Subject: Proposal for additions to the Transfer, Recycle, Resource Recovery and Processing Facility of AAA Hauling of NC, Inc.- Permit No. 26-13

PROJECT: AAA HAULING RECYCLING CENTER
1171 S. EASTERN BLVD. FAYETTEVILLE N.C.
SHEET: EQUIPMENT SLAB

SITE PLAN
SCALE 1" = 60'

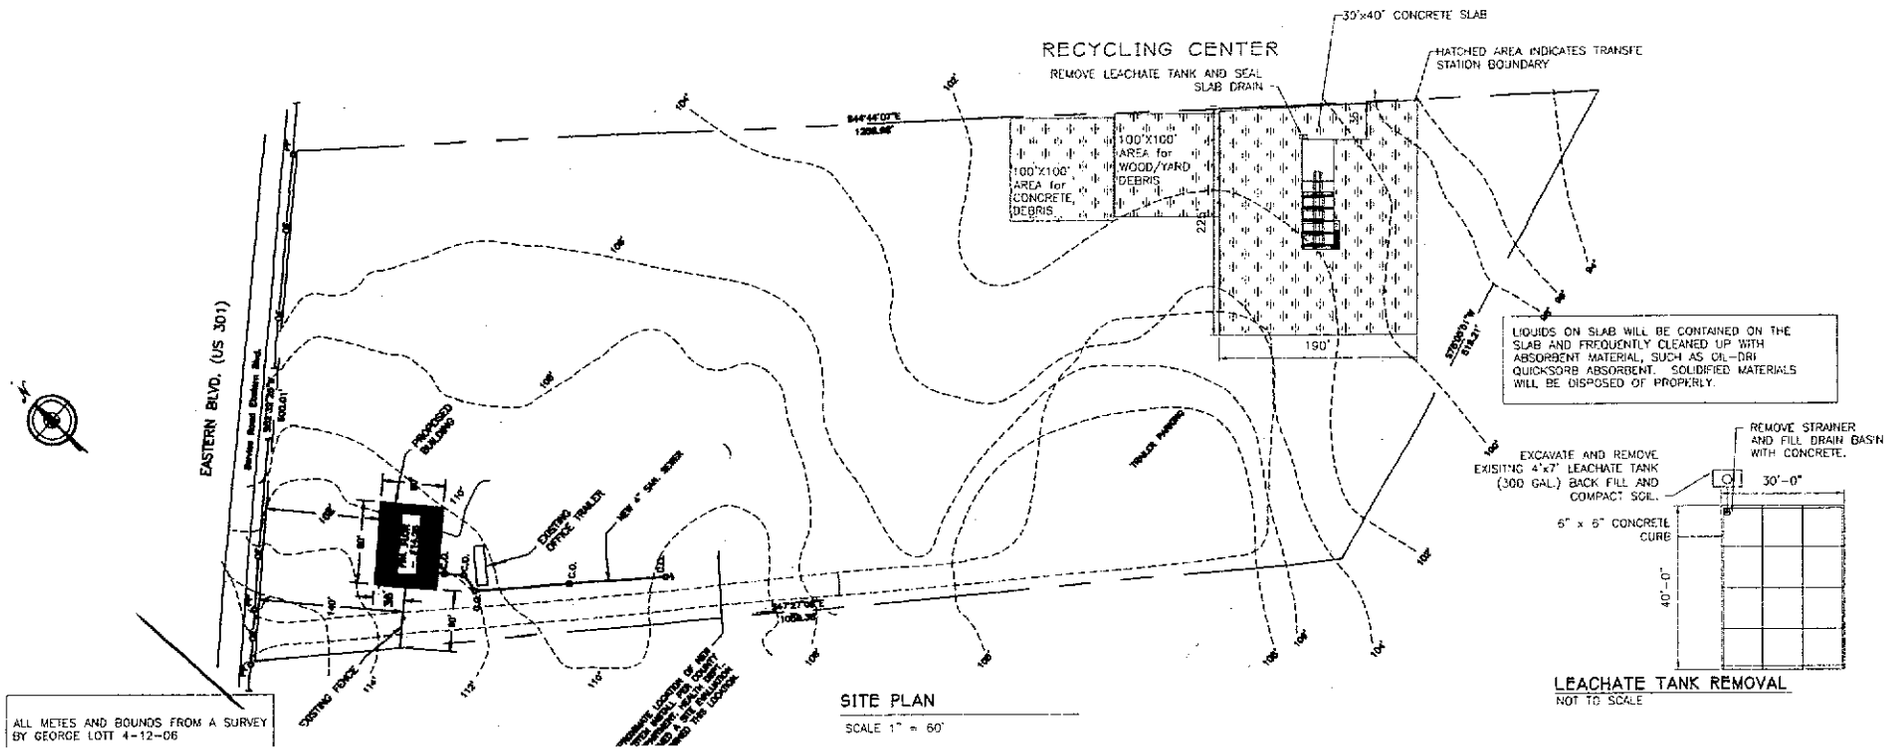
We are requesting at this time to install a picking station at our location to increase the percentage of recyclables from going to the landfill. Presently we estimate 30-50%. With the Picking Station, we estimate 70-85% after installation. Our operation plan shall remain the same with no changes needed.

We will be installing a picking station and screener at first and at a later date possibly erect a building to enclose the tipping pad and picking station. The drawing is an estimated size that we would like to install. Upon approval of these additions we will purchase the equipment and install them. The size may vary a little due to the manufacture that they are purchased from.

We would like to stockpile concrete, brick, asphalt for purposes of grinding to use as a renewable source. All paint, rebar and waste will be removed prior to stockpiling of materials. We would also like to stockpile land clearing debris and clean wood for the purpose of grinding to use as a renewable source. All waste will be removed prior to stockpiling of materials. With the stockpiling of these materials, we are minimizing the waste that would otherwise be dumped into the landfill. We can re-introduce these products back into the market place. This process will also give us the ability to hire more personnel and help the community as a whole.

LEACHATE TANK REMOVAL
NOT TO SCALE

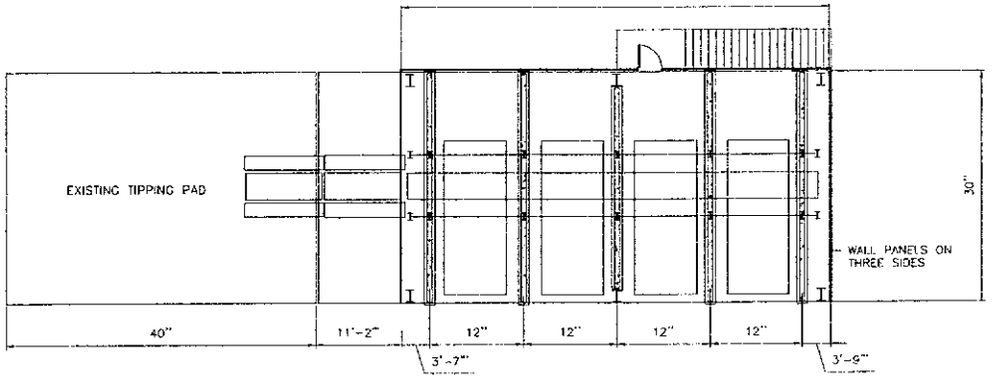
The Leach aid tank that has been installed is not in use. The weight of the dirt that covers it keeps collapsing the tank. We have the pipe valve shut off so no water drains in it. We are using speedy dry at the present time to absorb any liquids that are on the tipping pad and will continue to do this in the future. We will remove it from present location fill the drainpipe and return the tank to the supplier.
